#### TELEVISION TECHNICAL BULLETIN

59CS03H 66CS03H **MODELS** 51CS03H 66CS05H 51CS05H 59CS05H

Location of wire link on the component side of the PWB

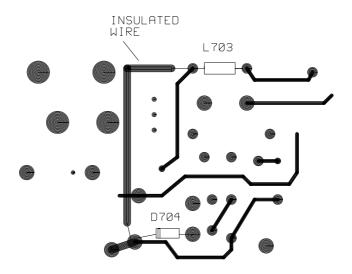
**SYMPTOM** The set remains in the standby mode.

**CAUSE** Crack on the PWB due to transport damage.

**ACTION** If there is no 300VDC across C708, then check the continuity between L703 and

the cathode of D704. If this is open circuit, fit a wire link between the two points

as indicated in the diagram below.

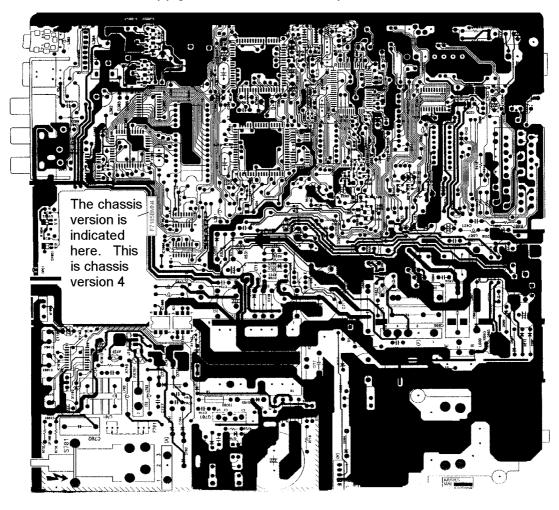
REASON From version 4 of this chassis, various changes have been made to the circuit.

When servicing chassis versions 4 or greater (see diagram below) use the 51CS05H (Part number SEKL51CS05H/1) or the 59/66CS05H (Part number SEKT66CS05H/2) service manuals.

Changes to the 51CS03H, 59CS03H and 66CS03H circuitry are :-

- 1. An audio mute circuit now incorporated into the chassis.
- 2. R631 and R632 have been added in series to the vertical +/-13V supplies.

For the 59CS03H and 66CS03H only R628, D616 and D621 have been added to the +45V supply line from the line output transformer.

The schematic diagrams on page 2 are based on the 59CSD8H.

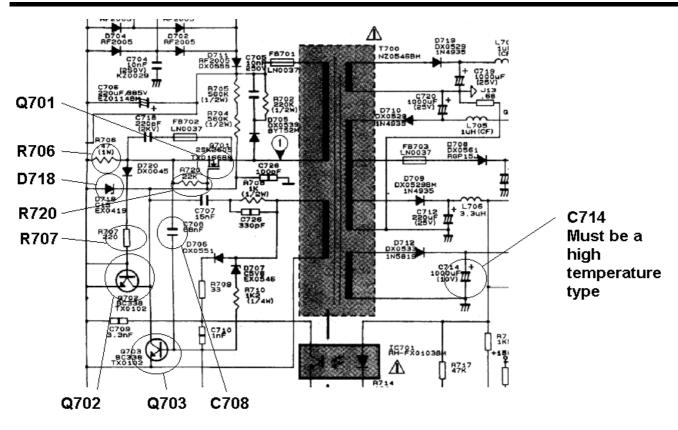
**SYMPTOM** The receiver can suffer from any of the symptoms listed below.

- Intermittent failure of Q601
- Intermittent failure of Q701
- No start up
- Q601 running excessively hot

**ACTION** Fit the CS Chassis kit, details given below.

Check the scan coils and scan coil plug for dry joints.

Ensure that the resistor next to C604 (R638) is at least 5mm away from the body of the capacitor. R706 is 0.33 Ohms in the 59CS05H and 66CS05H.

FIG 1 FIG 2

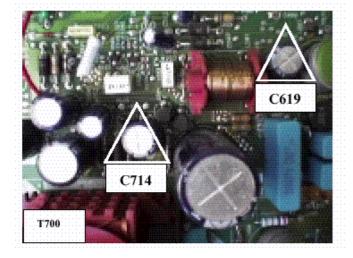
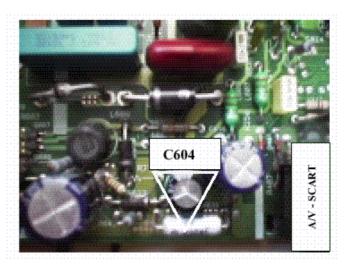
- Slow start up
- Intermittent text
- Intermittent OSD rolling
- Intermittent height problems
- Poor vertical linearity (cramping top or bottom of the picture)
- Intermittent failure on the line output transistor.

Failure of C604, C619 and/or C714. **CAUSE**

**ACTION** Replace the capacitors with high temperature types.

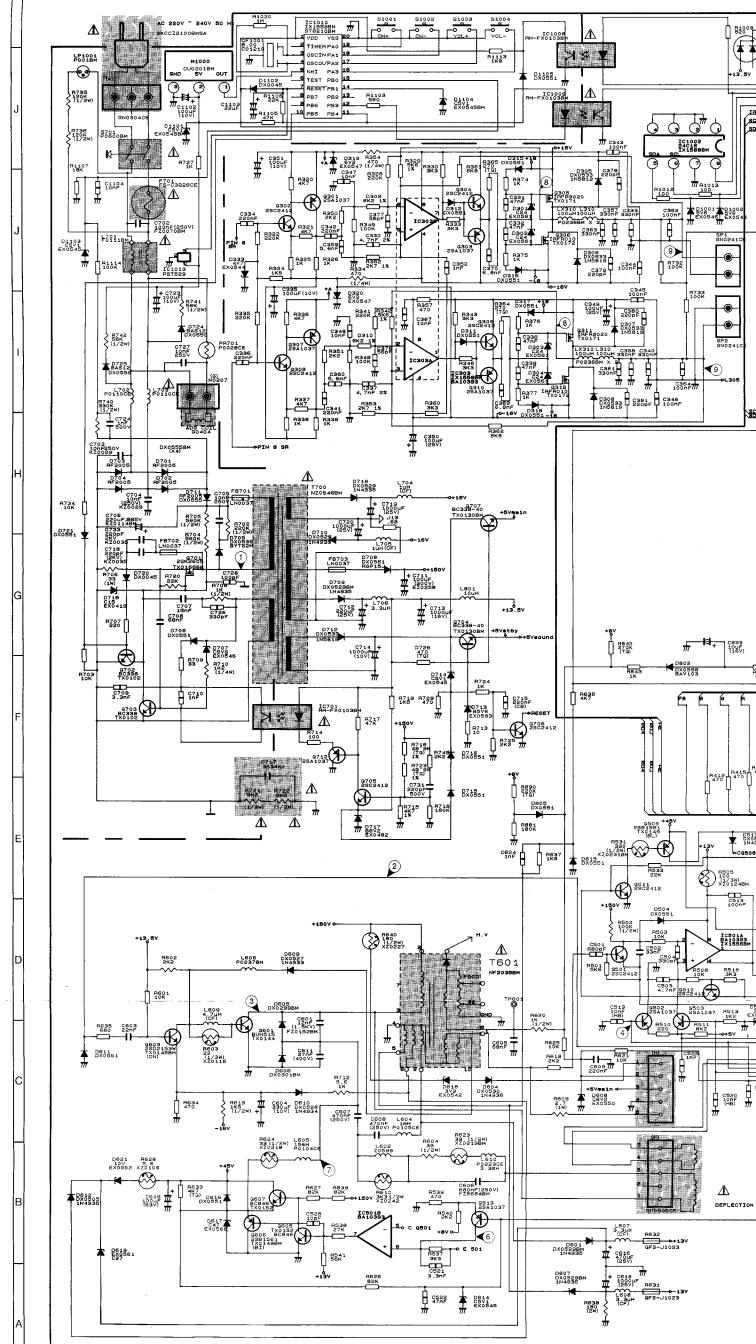
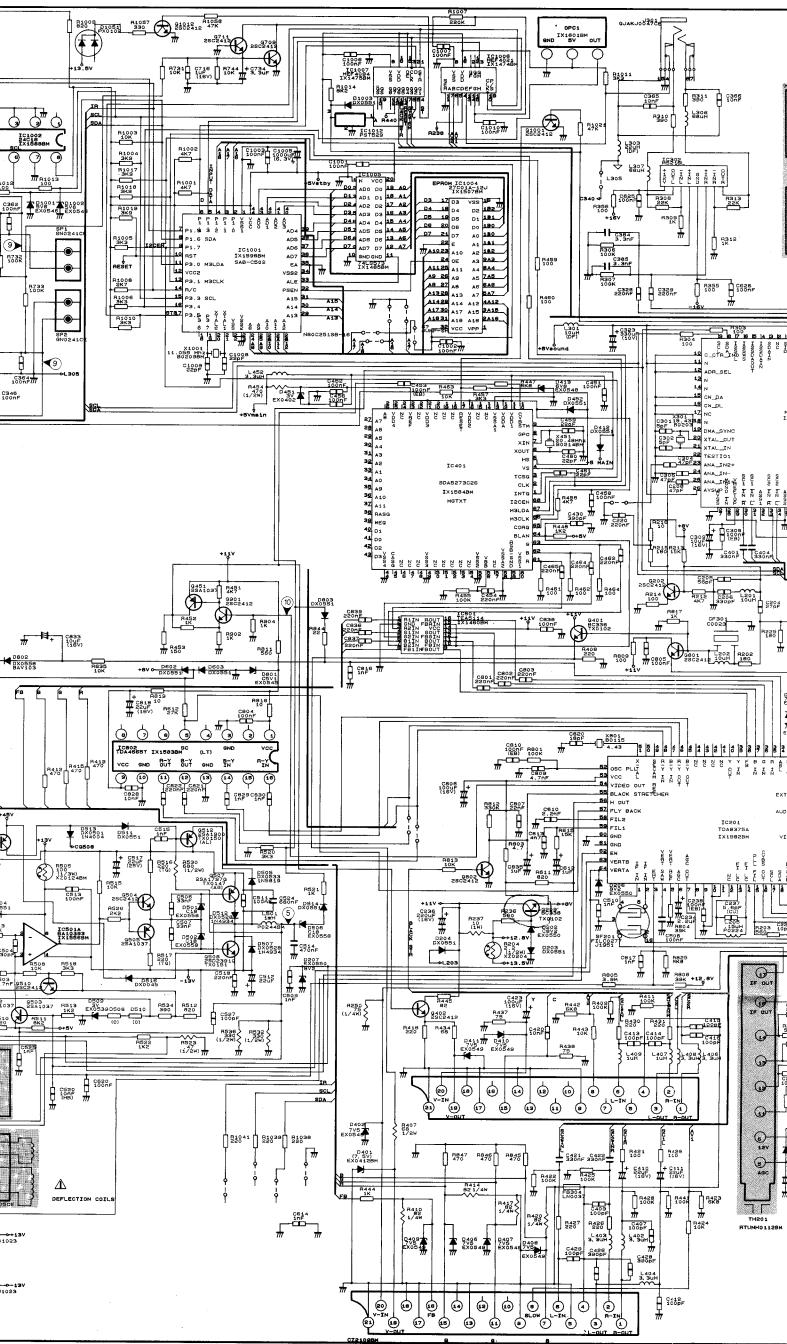
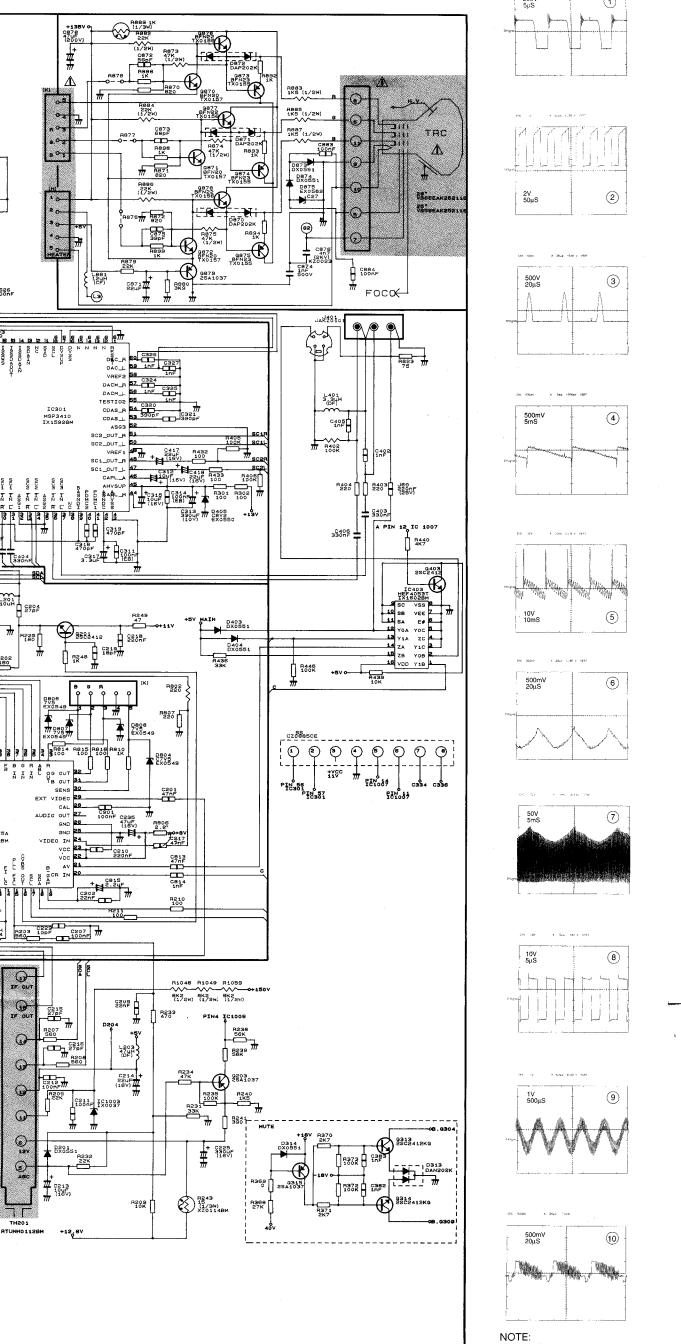
- **SYMPTOM** 1. Intermittent failure of one or both of the vertical supply line fuses (R631 and R632).
  - 2. Frame rises up when warm until there is a large black band at the bottom of the screen. This can eventually lead to the 'rainbow effect' at the top of the screen.
  - 3. Line tripping (same symptom when the Megatext IC goes faulty).
  - 4. Slow to come out of standby.

Breakdown of Q707, causing variation of the main 5V supply rail to the vertical stage CAUSE

This problem can be checked by measuring the voltage at the emitter of Q707 during ACTION

Note that Q707 can fail when C714 is replaced, so it is recommended that C714 is

changed at the same time as Q707.
